MONITORING AND REPORTING
PROGRAM NO. R6V-2006-0054

PACIFIC GAS AND ELECTRIC COMPANY
IN-SITU SOURCE AREA REMEDIATION PROJECT

Subject: *Comments on Tentative Waste Discharge Requirements for the In-Situ Source Area Remediation Project*

FIGURE 2
CONCEPTUAL PHASED
FULL-SCALE IN-SITU
SOURCE REMEDIATION APPROA
 PACIFIC GAS AND ELECTRIC COMPANY
 COMPRESSOR STATION
 HINKLEY, CALIFORNIA

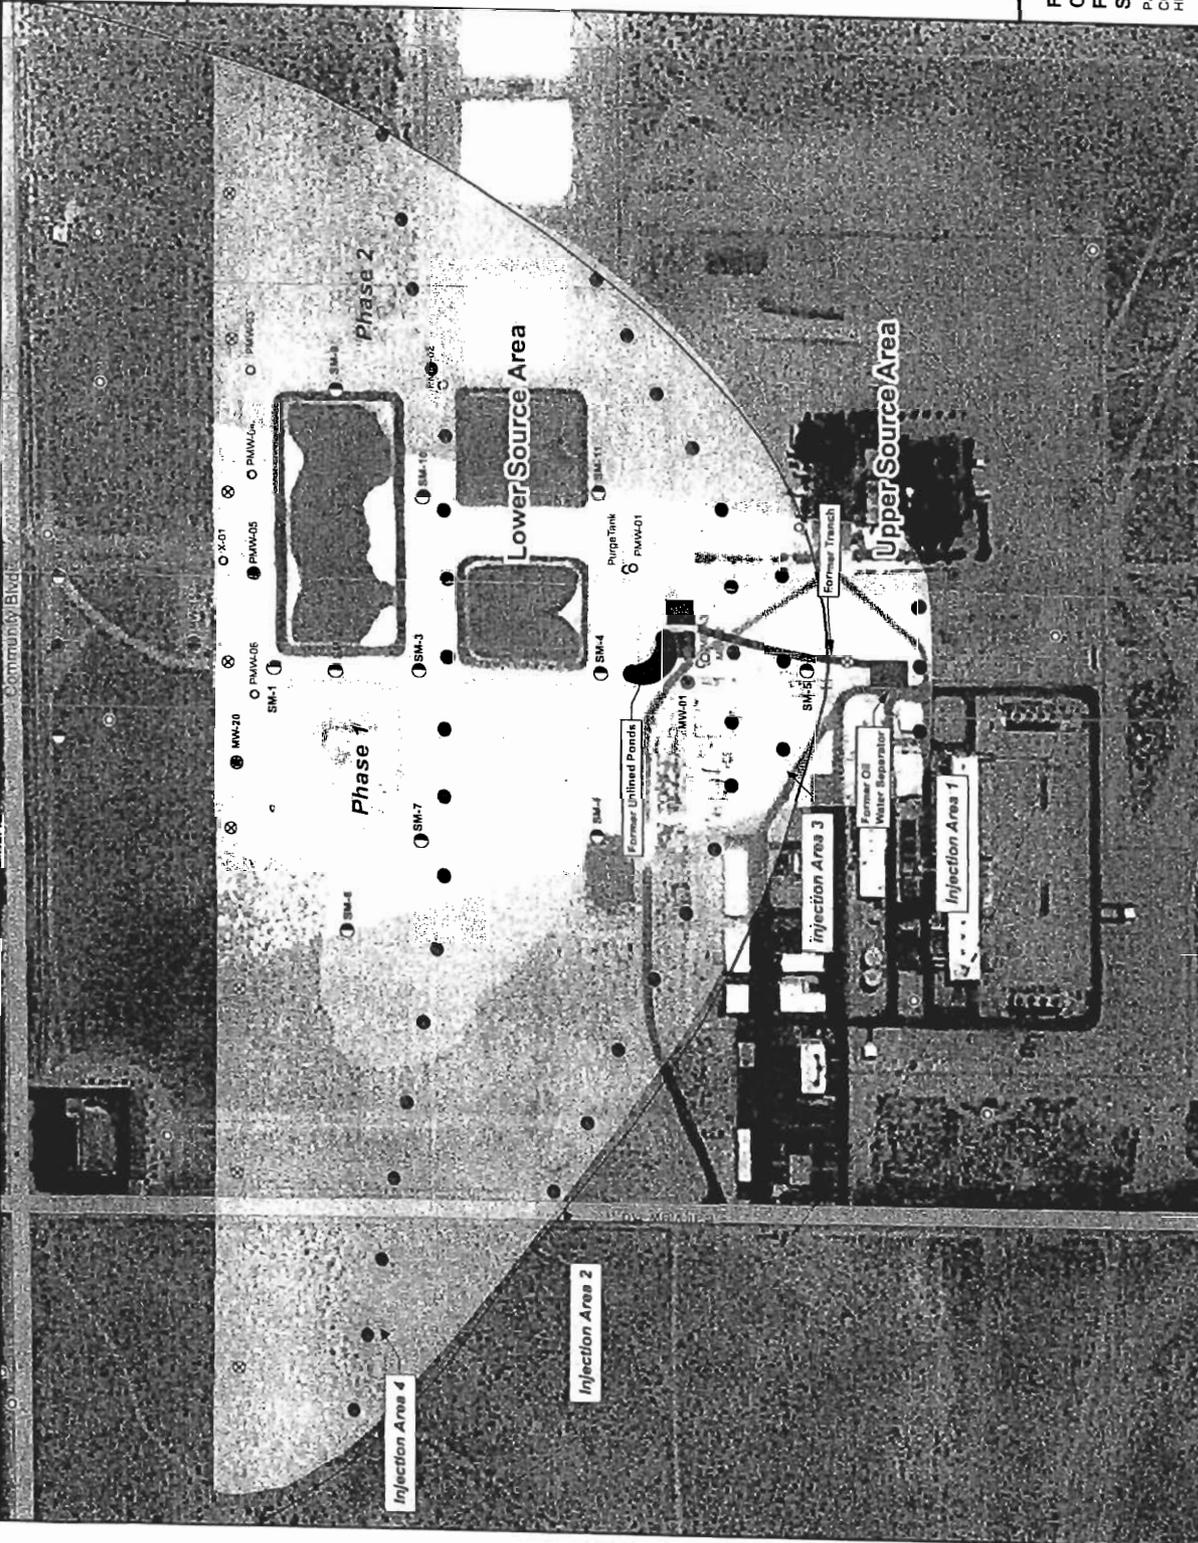
Page 4, Paragraph 11: In accordance with the August 4, 2006 response letter from PG&E to the Lahontan Regional Water Quality Control Board (LRWQCB) letter titled *Incomplete Report of Waste Discharge for the In-Situ Source Remediation Project, Hinkley Compressor Station, San Bernardino County - WDID No. 6B369107001* (attached for your reference), the project will be built and operated in up to two phases instead of three phases. Please replace Figure 2 with the revised Figure 2 from the August 4, 2006, PG&E response letter. For your convenience, a copy of the August 4 revised Figure 2 is attached.
